Exit wheel overload clutch with slower rotation when approaching the packet

GD X1 Exit overload clutch

Reduce the risk of machine damage with an exit overload clutch upgrade

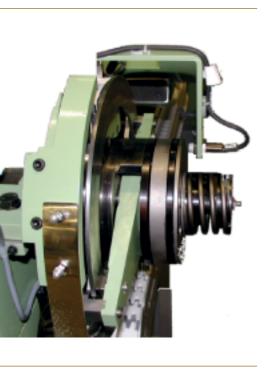
Issue Risk of machine damage

Excessive waste before machine stoppage

High impact on packet leading to quality issues

Removal of the exit disc and replacement with an exit wheel with clutch Solution

Immediate stop after jam

Different cam profiles for softer transportation
